19-PFD-0034
REISSUE

REISSUE - CONCLUSION OF COMMENT RESOLUTION ACTIVITIES FOR THE
CALENDAR YEAR 2014 HANFORD SITE MIXED WASTE LAND DISPOSAL
RESTRICTIONS (LDR) FULL REPORT, DOE/RL-2015-08, REVISION 0

The purpose of this reissue is to provide the updated compact disc that includes the correct
Redlined Calendar Year 2014 Hanford Site Mixed Waste Land Disposal Restrictions Full
Report, DOE/RL-2015-08, Revision 0.

**CALENDAR YEAR 2014 HANFORD SITE MIXED WASTE LAND
DISPOSAL RESTRICTIONS FULL REPORT**

Figure 7-1. Outline of Activities to Complete Treatment Plan.

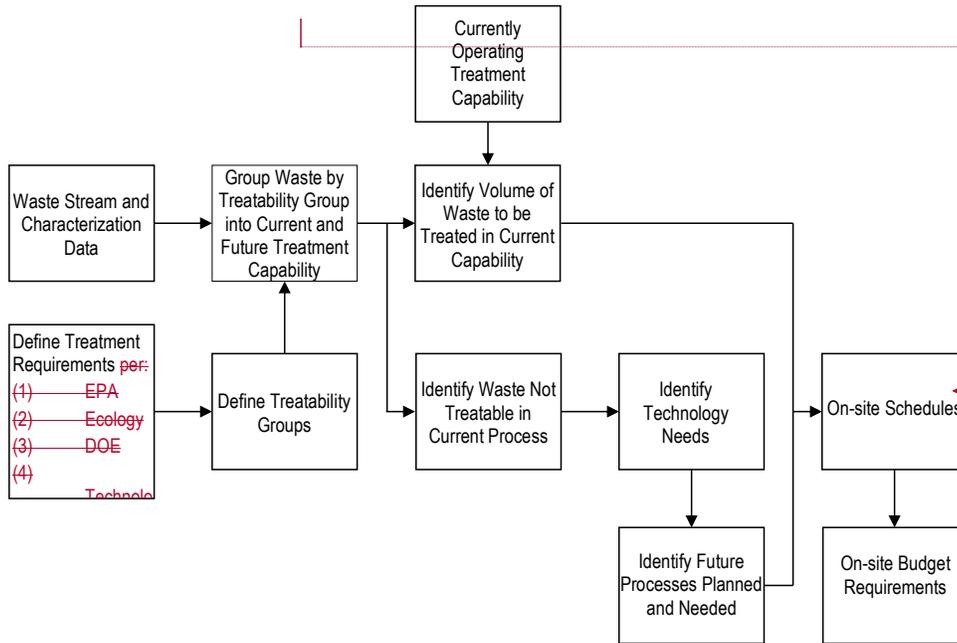
Commented [MM37]: #70

#	Page / Section	Text	Comment	Major issue	DOE's Proposed Response	Date Proposed	Ecology's Disposition	Follow-on Actions	Status
70	p. 7-3, Figure 7.1 (EPA)	Text box reading "Define Treatment Requirements per: (1) EPA (2) Ecology (3) DOE (4) Technology requirements	Given that the entire point of the LDR report is to establish plans and schedules necessary to achieve compliance with treatment standards under Ecology's authorized Land Disposal Restrictions program regulatory requirements, it is not clear why the various agencies are listed as the source of treatment requirements. This text box should read "Define treatment requirements pursuant to 40 CFR Part 268, incorporated by reference by WAC 173-303-140." What are technology requirements? Are they separate or distinct from LDR treatment requirements under the cited regulations?	Ed	Explain. Figure 7-1 provides an outline of activities to complete a treatment plan. It is not intended to be limited to identification of LDR regulatory standards. Although the regulations in 40 CFR 268 are applicable by reference at WAC 173-303-140, they were federally promulgated. Additionally, DOE requirements (e.g., for the radioactive component of the mixed waste) and technology requirements (e.g., consideration of the waste matrices in addition to the presence of RCRA constituents) must be considered for each planned treatment (e.g. for WIPP disposal).	07/20/17	Pending resolution of 2014LDR-031 <u>Ecology:</u> <u>Define treatment requirements pursuant to 40 CFR Part 268, incorporated by reference by WAC 173-303-140. LDR treatment standards are defined in 40 CFR 268. Any variances or equivalent treatment methods needed for example due to the radiological nature of the waste are granted by EPA are through 40 CFR 268.</u> <u>Reorganization of Treatability Groups is on the PARKING LOT for next full LDR Report.</u>	2014LDR-031 (DOE) Propose substitute language for text box. DOE provided the following suggested markup on 07/29/17 for planned 08/03/17 discussion. Define Treatment Requirements per: (1) EPA (2) Ecology (3) DOE (4) Technology requirements	Open Closed <u>11/7/18 Parties agreed to deletion of text in the box.</u> <u>11/27/18 Parties agreed to strike-out Parking Lot text in "Ecology's Disposition" column.</u>

Figure 8-1. Correlation Between Mixed Low-Level Wastes and Treatment Facilities.

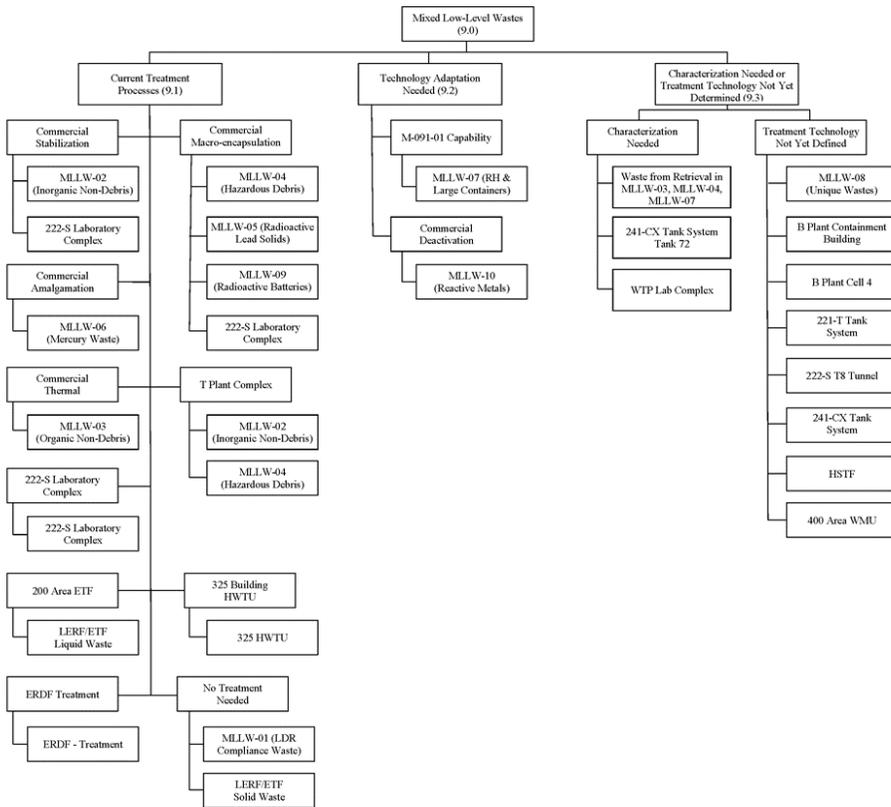
Commented [MM38]: #73. Need to insert revised Figure for 2019 Report.

73	p. 8-2, Figure 8-1. Correlation Between Mixed Low-Level Wastes and Treatment Facilities. (Comp)		Under current treatment processes, if there is no treatment needed for ERDF treatment (MLLW-01 and LERF-ETF) should not be included. Under characterization needed - no treatment yet defined, B Plant covers canyon only. 221-T Tank System does not cover 2706 tank system.	T	Accept.	05/11/17	Concurred with noted changes on 07/20/17.	2014LDR-012 (DOE) Determine where LERF/ETF Solid Waste that is NOT LDR compliant belongs in this graphic. Closed 06/15/17 with the addition of LERF/ETF to Figure 8-1. 2014LDR-015 (DOE) Review and update Figure 9-1 to include LERF/ETF solid waste. Closed 07/20/17.	Closed

Figure 8-2. Correlation Between Transuranic Wastes and Treatment Facilities.

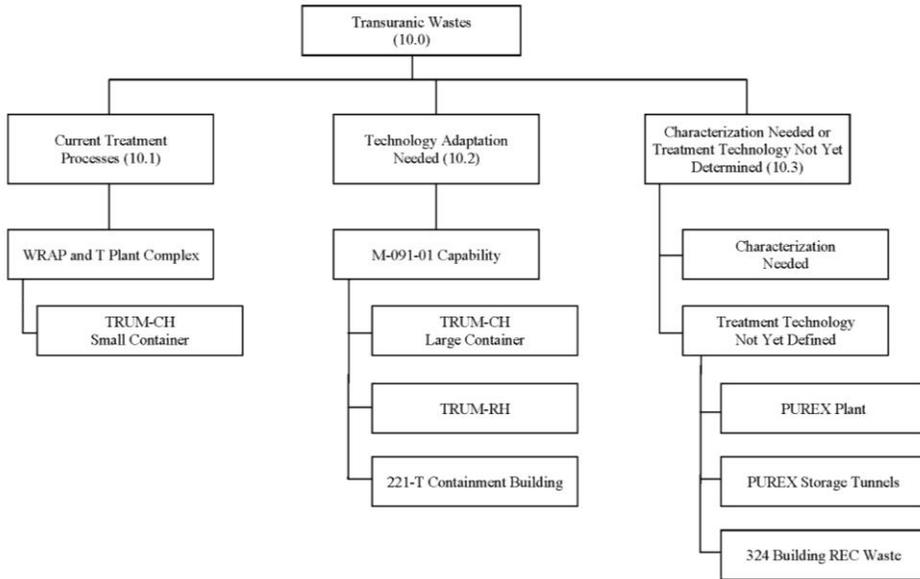
Commented [MM39]: #74 Need to insert revised figure for 2019 Report.

Figure 9-2. Disposition Map for Treatability Groups Needing Facilities
Adapted to Allow Waste Treatment.

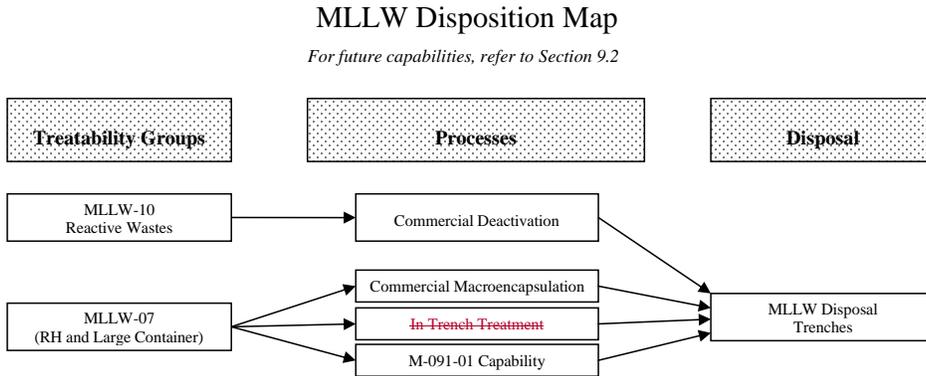
Commented [MM40]: #76 Need to insert revised figure for 2019 Report.

76	p. 9-2, Fig 9-2 (EE)	"In Trench Treatment"	This needs to be removed from the figure as it is not allowed under LDR regulations. It should be noted that EPA's CERCLA office is seeking a variance to continue using in trench treatment at ERDF for large equipment. That is a different issue though.	Err, Ed	Accept. Modify Figure 9-2 as shown: 	07/20/17	Ecology concurred as proposed 07/20/17	None	Closed
77	p. 9-2, Section 9.1 (EPA)	General	This section begins with text reading "This section generally describes each treatment process and provides information concerning the processes identified in Figure 9-1." However, the various subsections of Section 9.1 variously describe treatment processes (e.g., Commercial Macroencapsulation, thermal treatment of organics) and locations (T-Plant, 222-S) that are either not specific to any particular treatment process or do not have treatment processes. This is very confusing. More specifically, the description of the T-Plant Complex in Section 9.1.4 does say "Commercial treatment of waste by stabilization and macroencapsulation to meet land disposal requirements could be supplemented or replaced by capabilities that exist within the T Plant Complex," but the description of two several dangerous waste management units (The T Plant Complex canyon, assumed to mean the 221-T canyon	T	None	06/15/17	Pending resolution of 2014LDR-020. Note associated comments 77, 96 Revisions do not completely address comment. See yellow highlight.	2014LDR-020 (DOE) Propose revisions to Chapter 9 Response: Proposed redline/strikeout changes are attached in 2014LDR-020. Subsequent reorganization/rewriting of the report may be considered. ACTION CLOSED	Open/closed 11/29/18 Parties agreed on the following language: "... could be supplemented or replaced by capabilities that exist, and could be developed within the T Plant Complex ..." Start of Comment Resolution Meeting #4 on November 29, 2018

Figure 10-1. Site Disposition Map for TRUM Treatability Groups.

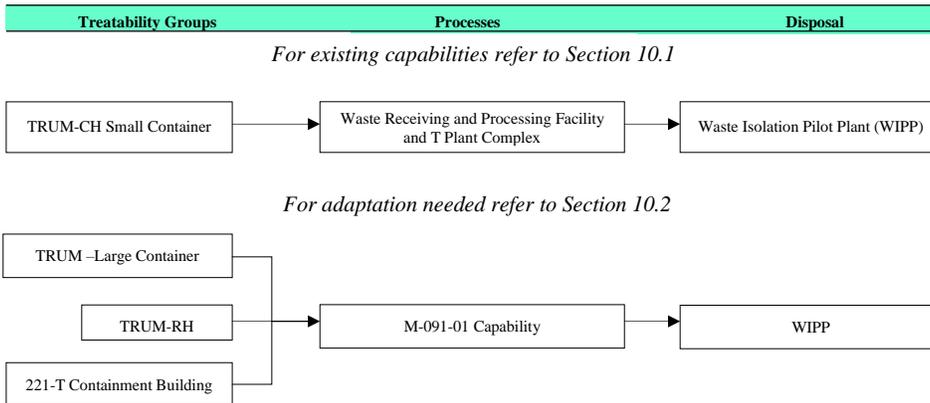
105	p. 10-1, Fig 10-1 (EE)	WRAP and 221-T listed as existing capabilities	I think this is a misrepresentation of the situation. WRAP is not ready to process any of the M-091 waste and is planned to be shut down. 221-T has the to process large and RH containers, but does not possess that capability right now.	Err	Explain. A determination to put WRAP into closure has not been made. We agree the capability will be developed under M-091.	07/20/17	Ecology withdrew comment on 07/20/17	None	Closed
106	p. 10-1, Fig 10-1 (EE)	The figure shows 221-T as the only TRUM-RH facility.	The PUREX Tunnels need to be added to this group.	Err	Reject. The PUREX tunnels path forward is not yet determined. See PUREX Tunnels TGDS Section 5.0.	07/20/17	Ecology withdrew comments on 07/20/17	None	Closed
107	p. 10-2 and 10-3, Section 10 Tables Tables (Comp)	e.g. Projected volume of MLLW to be treated between CY 2015 and the end of CY 2019 Processing of mixed waste will be performed in accordance with TPA milestones, permit requirements, CERCLA RODs, and state Dangerous Waste Regulations (WAC-173-303).	DOE-RL-2015-08 does not specify volumes treated in the Section 9 and Section 10 Tables but rather uses generic language. Past year reports used specific volumes when it was available	Ed	Reject. This comment is in reference to projected volume of MLLW to be treated between CY 2015 and CY 2019. There is no requirement to report projected volume to be treated, only projected volume to be generated. DOE recommends deletion of this information from the LDR Report. See also comments 83 and 100.	07/20/17	Pending resolution of 2014LDR-033 Response to comment does not address lack of projected treatment volume information. See "LDR Report Issues for Discussion" handout (Issue 9) provided at the	2014LDR-033 (DOE) Propose modifications to Chapter 9 tables Response: Proposed redline/strikeout changes are attached in 2014LDR-020. Subsequent reorganization/rewriting of the report may be considered. ACTION CLOSED	Open Closed 12/13/18 Parties agreed to close in 2014 Report and place treatment volumes in 2019 Full LDR Report.

Figure B-1 markup

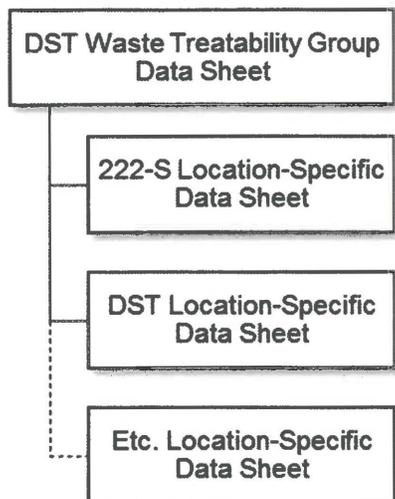
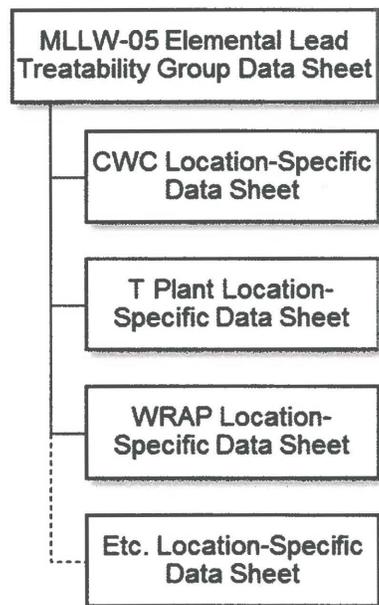
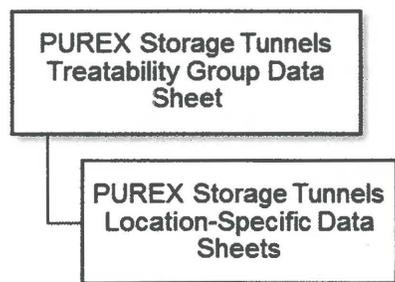
Commented [MM73]: #142 – 145. Insert new Figure B-1. Figure B-1 markup

144	p. B-1, Text accompanying Figure B-1 (EPA)	The LDR report requires both to provide a clear picture of each waste stream.	Whatever may be "a clear picture" needs to be defined in terms of the FFCA, the FD and the 1990 document. Suggested text change: "The combination of TGDS and LSDS provide the information required to be included in the LDR report by the 1990 LDR Report Requirements document." This comments pertains to language "present a complete picture" shown in Figure B-1 with the PUREX Storage Tunnels information.	T, TS, S	Modify text as shown in attached Figure B-1 markup .	04/26/17	Ecology concurred as proposed on 04/26/17.	None	Closed
145	p. B-1, Text accompanying Figure B-1 (EPA)	LSDSs for generating locations contain the current facility inventory of this waste	To avoid confusion as to the meaning of "facility," this text should be re-written to read: "LSDS for generating locations contain the current inventory of this waste at the generating location."	Ed	Modify text as shown in attached Figure B-1 markup .	04/26/17	Ecology concurred as proposed on 04/26/17.	None	Closed

Each TGDS consolidates information about wastes represented by has one or more LSDS associated with it. The TGDS is used to associate these wastes with the treatment technologies described in the full report. The LSDS describe on a plant/unit/project basis how, where, and how much of the waste is stored, and give a glimpse of the waste's past and future. The LSDSs provide certain information specific to waste streams within treatability groups that is not reflected in TGDSs. Unique information is included on LSDSs that is not reflected on TGDSs. The information in both the TGDSs and LSDSs is required to satisfy reporting requirements as listed in Table A-1. LDR report requires both to provide a clear picture of each waste stream.

This is an example of data sheets for mixed waste stored "long-term." Both a Combined, the TGDS and a LSDS address the requirements outlined in EPA and Ecology's 1990 Requirements for Hanford LDR Plan are required to present a complete picture of the waste.
